# PREVOST

**WB25-01A**

DATE :	March 2025	SECTION :	18 BODY
EXPIRATION:	March 2027		
SUBJECT :	<b>WATER INFILTRATION IN THE MODESTY PANELS</b>

Revision: A

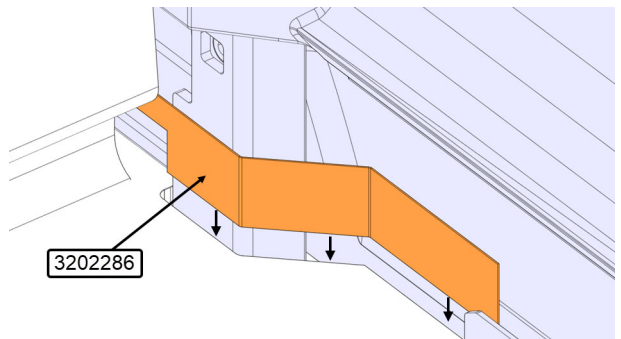
4. Slide the dam plate 3202286 between the floor and the modesty panel structure.

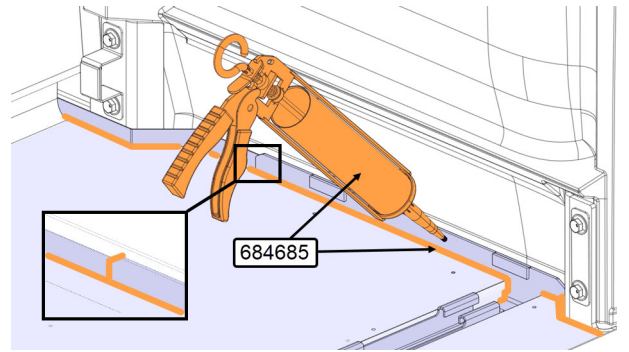
5. Apply sealant 684685 to the joint between the floor and the bottom of the modesty panel and seat track.

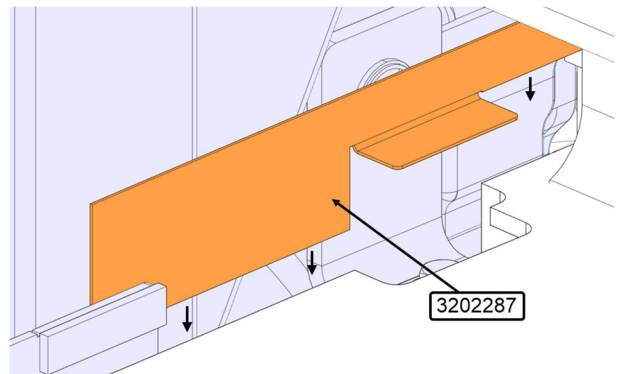
4. Slide the dam plate 3202287 between the floor and the modesty panel structure.

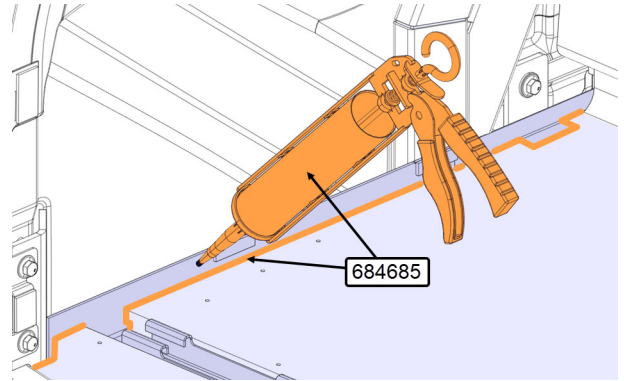
5. Apply sealant 684685 to the joint between the floor and the bottom of the modesty panel and seat track.
